US 29 - Fairland Road to Musgrove Road, Interchange Improvements, Mandatory Referral No. 2016002

We recommend that the Board DISAPPROVE this project with the following comments to the Maryland Department of Transportation:

Figure 1: Planned Interchanges along US29 in the Fairland Master Plan

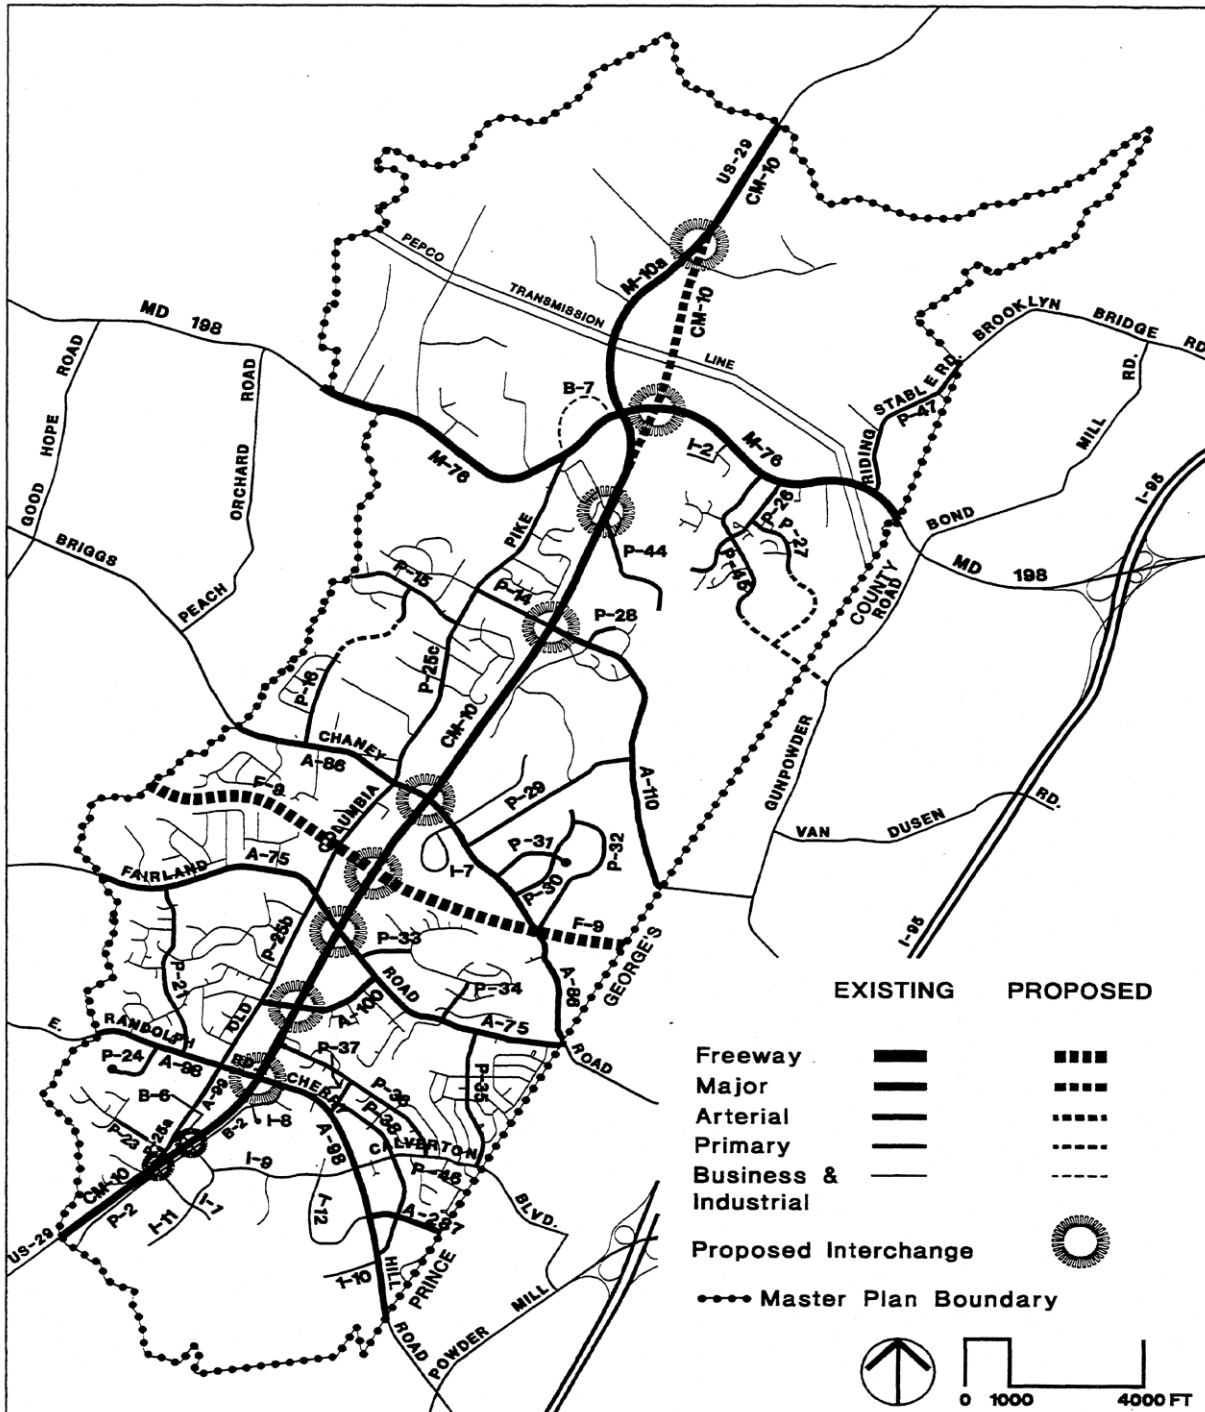
Ultimately, a completely grade-separated facility is planned along US29 between the New Hampshire Avenue (MD650) interchange and the Howard County line (see Figure 38 above). Five interchanges have been built: Randolph Road/Cherry Hill Road, ICC, Briggs Chaney Road, Spencerville Road (MD198), and Dustin Road; and four others are yet to be funded for design (Stewart Lane, Tech Road/Industrial Boulevard, Greencastle Road, and Blackburn Road).

specific recommendation on Musgrove Road other than the interchange shown on Figure 38 on page 89 (see Figure 1).

The 1997 *Fairland Master Plan* recommends interchanges at both Fairland Road and Musgrove Road. However, this project would close the current at-grade intersection with Musgrove Road with no provision for a future interchange. Since the overall rationale for the larger objective of converting US29 into a grade-separated facility is to improve east-west travel and connectivity, the proposed project's elimination of the Musgrove Road bridge over US29 is counterintuitive since it reduces connectivity and would create a more circuitous travel pattern. The current design of the US29 on and off ramps was developed to provide safe weaving distances between the subject project's ramps and those of the existing US29/Intercounty Connector interchange immediately north. SHA believes the proposed configuration is optimal among the alternatives studied, however the proposed ramps on the east side of US29 would prove to be confusing to users traveling from Fairland Road bound for US29 north as they would have to travel a considerable distance south before heading in their intended direction. In addition, this ramp arrangement would require a large amount of new pavement compared to the alternative that included a Musgrove Road bridge over US29 and ramps between Musgrove Road and northbound US29.

Staff believes that the project should include a Musgrove Road bridge over US29 and a more straightforward travel pattern that maintains the existing roadway pattern. We find therefore that
